June 30, 2006

Re: Cell 4A Lining System Design Report, Response to DRC Request for Additional Information – Round 2 Interrogatory, Cell 4A Design.

We are responding to your June 14, 2006 letter, requesting additional information following on the Cell 4A Lining System Design.

Figure 6. Water Content Versus Time for Samples of Gundseal Placed in Contact with Sand at Various Water Contents.

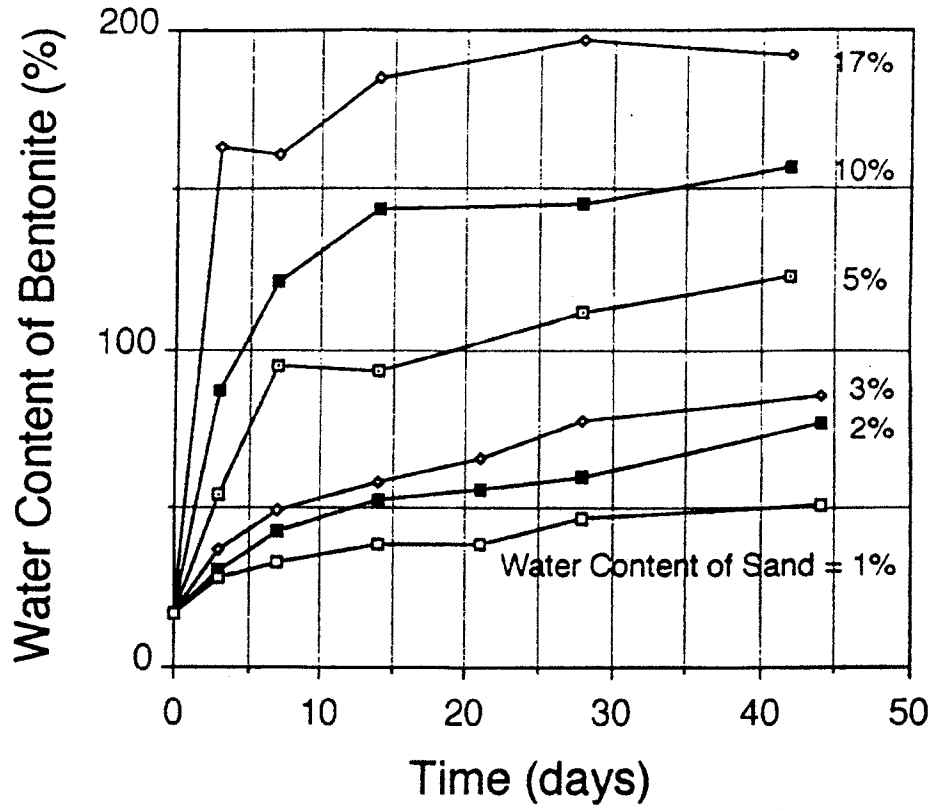
6. *Additional GCL Data – that the GCL will resist damage/degradation due to exposure to the leachate and freeze/thaw action. Include data on the hydration of the GCL and the potential impact of freeze/thaw on the GCL in the exposed portion of the liner system.*

The performance of the bentonite clay component of the GCL is derived from the ability of the bentonite to hydrate (absorb water). Bentonite clays have been shown to absorb water from adjacent soils with moisture contents as low as 1% (Daniel, et. al. 1992). Based on the construction records for the clay liner and dike construction (Appendix D of Design Report), the average dike soil moisture content was approximately 13.0% and the average clay liner soil moisture content was approximately 18.6%. As illustrated in Attachment A (Daniel 1992), a soil with a moisture content of 10% will allow the bentonite component of the GCL to reach a moisture content of approximately 140% at approximately 15 days. After

approximately 45 days, bentonite adjacent to soil with moisture content higher than 10% will hydrate to a moisture content of between 150% and 200%. Based on the construction schedule and the anticipated regulatory approval time, the GCL will be hydrated long before the cell is placed in service.

Figure 2

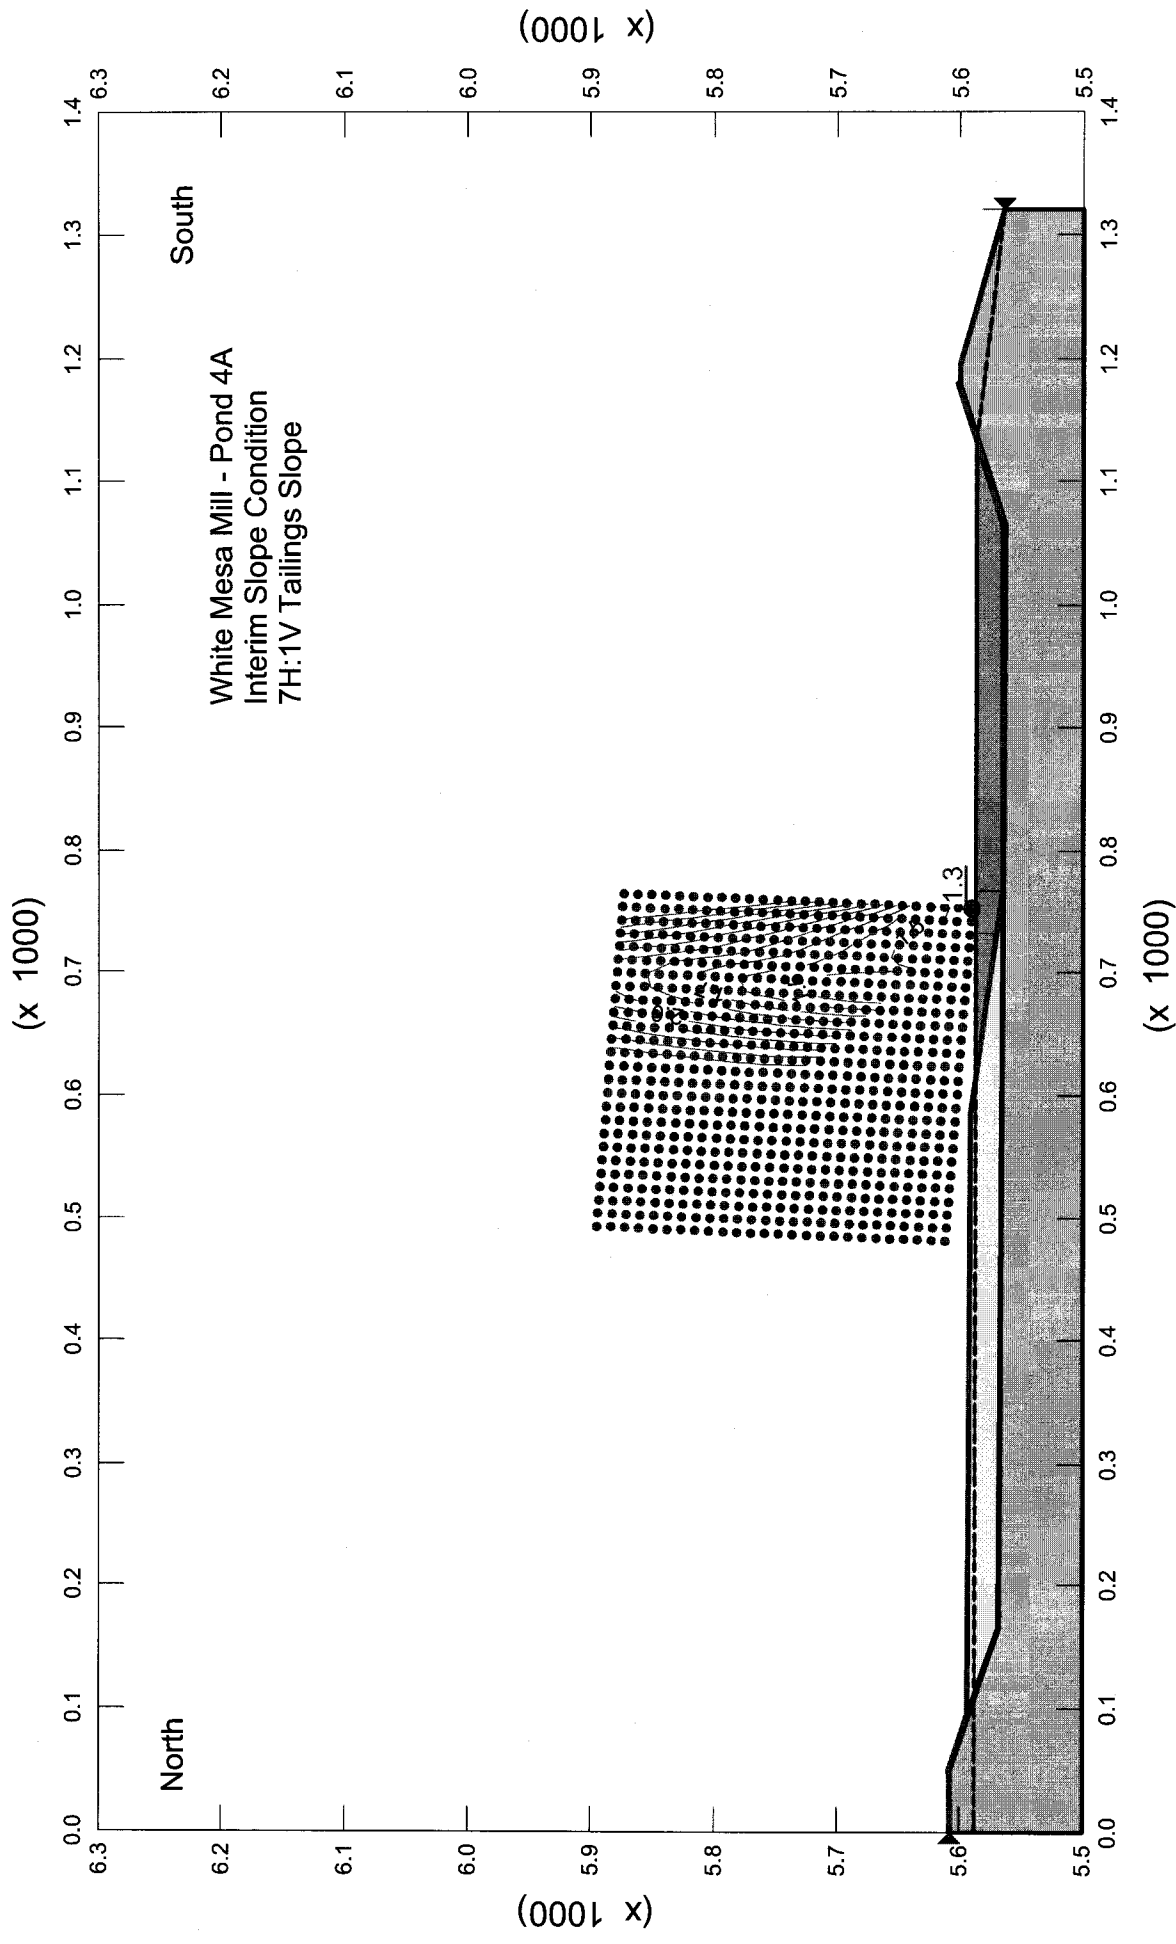
7. Construction and Operational Loading – Detailed procedures that cover installation of the cell and operation of the cell.

The tailings, consisting of medium to fine sands with silt and some clay, will segregate upon entering the liquids in the cell. The sands will drop out of solution soonest while the silt and clay fraction will be suspended longer and tend to drop out of solution further from the discharge pipe. Based on a review of existing operations in the existing cells at the facility, we have assumed the cell will be filled to approximately one-half of full height with liquids (approximately 20 feet) and that tailings may extend up to approximately 5 feet above liquid levels in the cell. In the modeling, the phreatic surface (liquid surface) is assumed to apply to only the waste and liner materials, since the composite liner system essentially eliminates infiltration of liquids into the underlying subgrade/foundation. Although tailings placed from a fluid deposition process are anticipated to develop a very shallow slope (i.e. beach) that is likely 10H:1V (Horizontal to Vertical) to 20H:1V or shallower, the analyses assumed a maximum slope inclination of 7H:1V. Based on these input parameters, along with the anticipated liner interface shear strength, a factor of safety value of 1.3 is obtained for a very small, shallow failure at the toe of the interim slope of the tailings. The slope stability analyses are presented in Attachment B.

Numerous potential failure surfaces were performed to evaluate various slip surface geometries and to identify the critical slip surface. The results of this analysis indicate a minimum static factor of safety of approximately 1.3 assuming waste slopes inclined at approximately 7H:1V, as

shown in Figure 2. This failure surface is a very small, shallow failure at the toe of the interim tailings slope. Much higher factor of safety values are obtained for larger failure surfaces.

We recommend that interface testing of the liner system be performed during construction quality assurance to verify that the interface friction angles used in this analysis for the liner system are met or exceeded. Further, we recommend that operations at the site limit the tailings/waste deposits slope to inclinations of 7H:1V or flatter.

SETTLEMENT EVALUATION OF BERMS

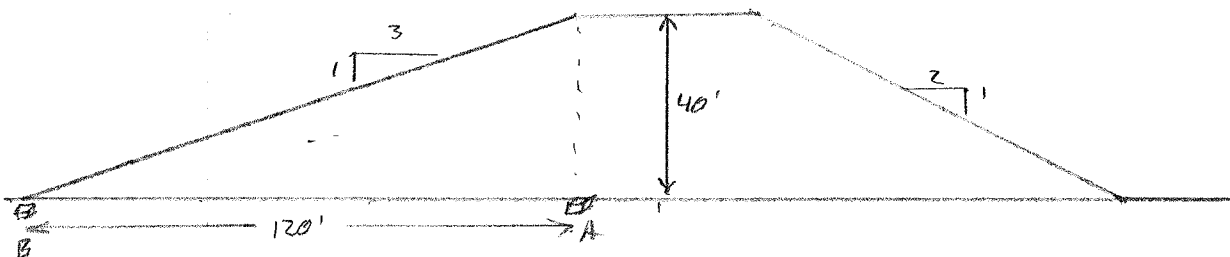
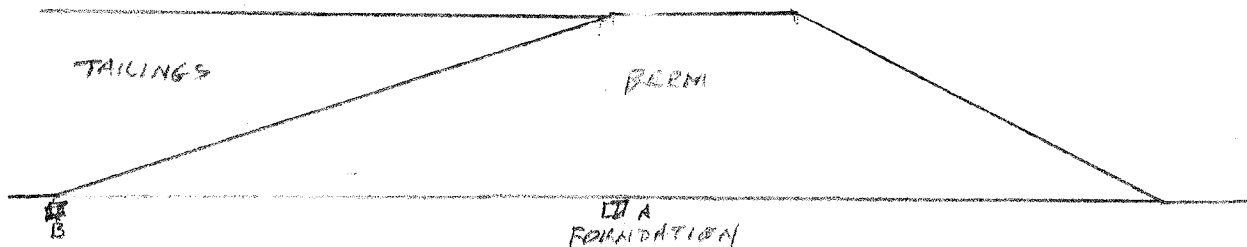
8. Settlement Evaluation – to evaluate anticipated settlement of the liner at the cell bottom and sideslopes under static conditions of the final cover system.

Cell 4A was constructed by removal of natural overburden soils and approximately 10 to 20 feet of undisturbed Dakota Sandstone upstream of the compacted fill creating the dikes. The majority of the Cell 4A tailings and cap material will be supported by the Dakota Sandstone formation, except for the small vertical component on the dike slopes. The estimated differential settlement of the dikes after placement of the waste materials within Cell 4A is approximately 2.4 inches from the top of the slope to the base of the slope. This value is conservatively estimated based on conservative modulus of elasticity values for the underlying materials. Based on this differential settlement, a potential strain of 0.16% will develop within the side slope liner system geosynthetic materials. This strain is well below the typical strain values that HDPE geomembrane, geonet, and GCL materials can withstand. The estimated differential settlement calculation is presented in Attachment C.

SETTLEMENT UNDER A = 4.4 in
 " " B = 2.5 in

$$\Delta S = 1.9 \text{ in}$$

$$\text{STRAIN IN LINER IS } \frac{1.9}{(126.5)(12')(\text{ft})} = 0.13\%$$

DIFFERENCE IN SETTLEMENT BETWEEN B AND A
 IS $8.45 - 6.01 = \underline{2.44 \text{ in}}$

STRAIN IN LINER $\frac{2.44}{(126.5)(12)} = \underline{0.16\%}$
